DEVELOPMENT APPLICATION ASSESSMENT REPORT

Application Number:	DA2022/0448
----------------------------	-------------

Responsible Officer:	Dean Pattalis
Land to be developed (Address):	Lot G DP 408223, 7 Cooleena Road ELANORA HEIGHTS NSW 2101
Proposed Development:	Subdivision of one lot into two and partial demolition of existing dwelling
Zoning:	C4 Environmental Living
Development Permissible:	Yes
Existing Use Rights:	No
Consent Authority:	Northern Beaches Council
Delegation Level:	NBLPP
Land and Environment Court Action:	No
Owner:	Ianni Family Pty Ltd
Applicant:	Ianni Family Pty Ltd

Figure 1: *Location of the proposed indicative dwelling on Lot 2 as viewed from a ground floor bedroom of No.5 Cooleena Road*

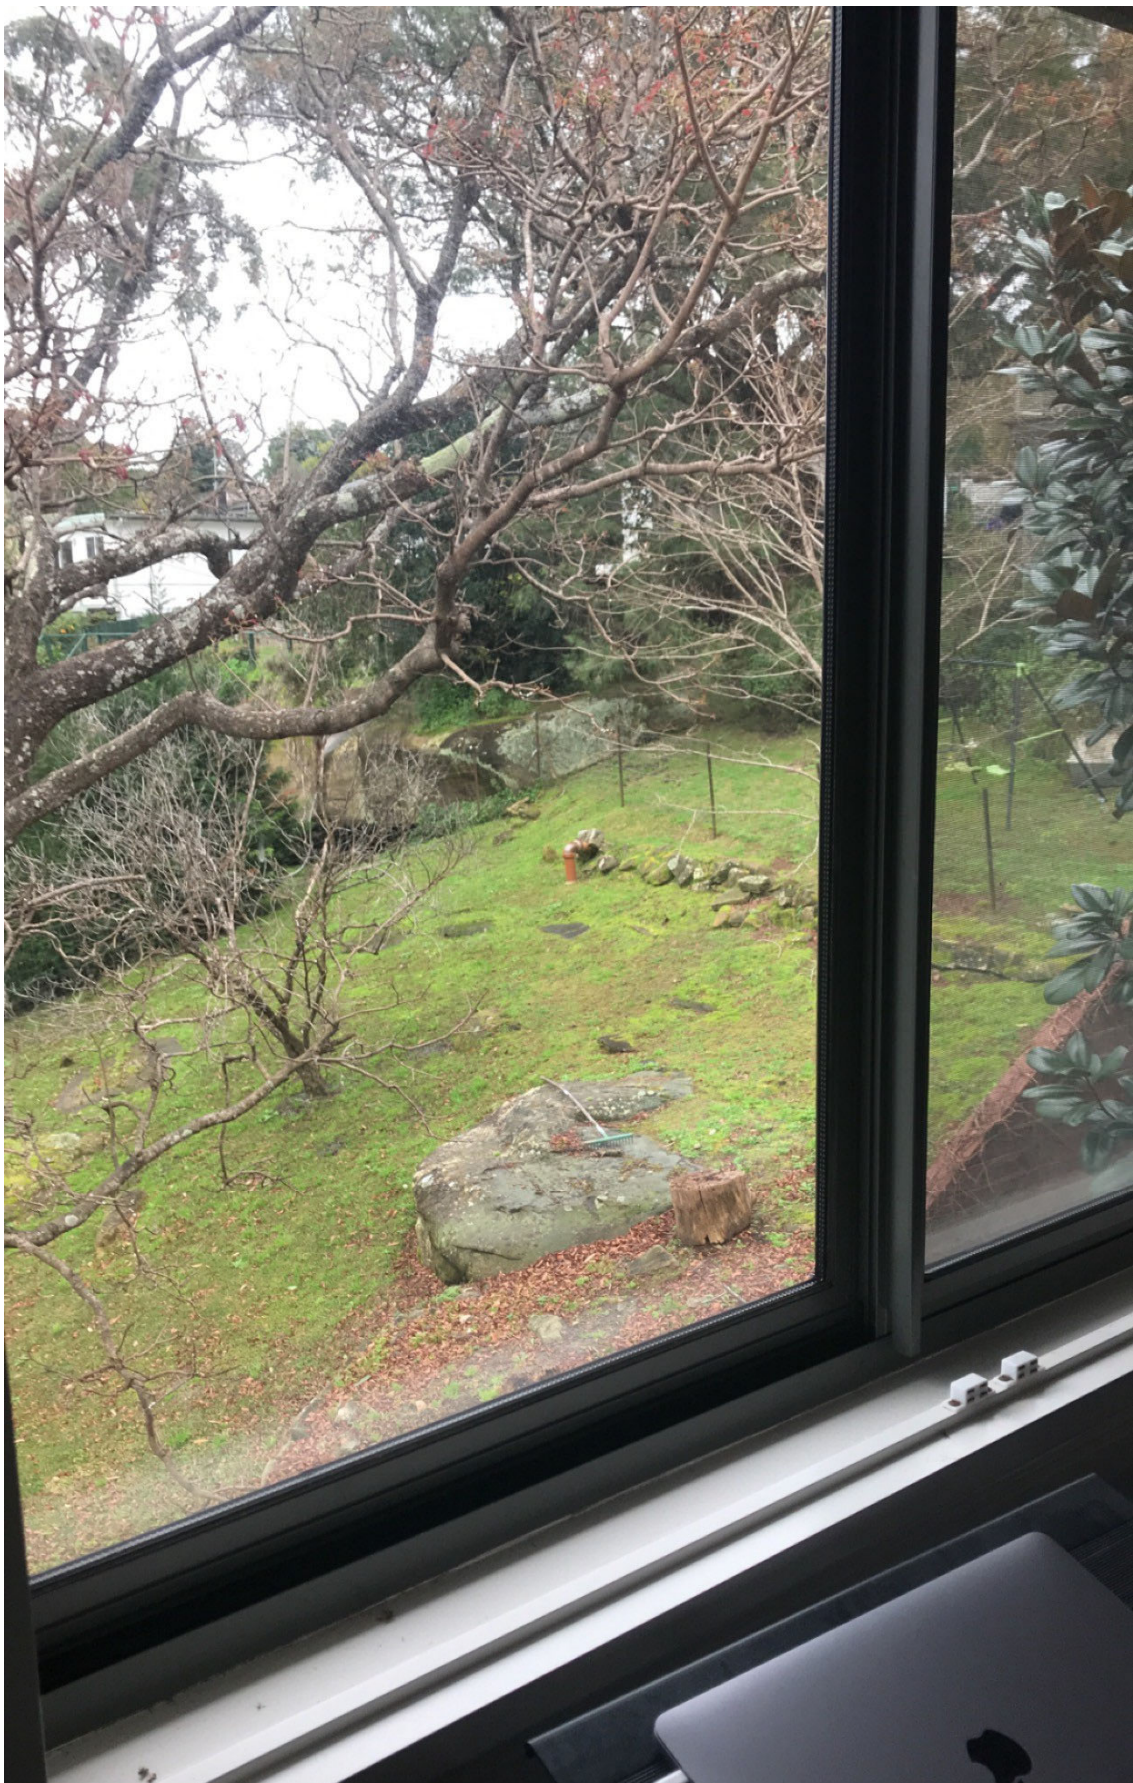
View loss concerns were raised by the adjoining property owners to the east (No.5 and No.5A Cooleena Road) and as a result, a site inspection was undertaken. Following the inspection, the affected views related to areas of vegetation and open space only. It was considered that the perceived loss of views related more specifically to the loss of a feeling of openness resulting from the location of the indicative dwelling on Lot 2, rather than a loss of any valuable iconic or water views. A full view loss assessment under the principals of Tenacity Consulting v Waringah [2004] NSWLEC 140 is therefore not considered necessary.
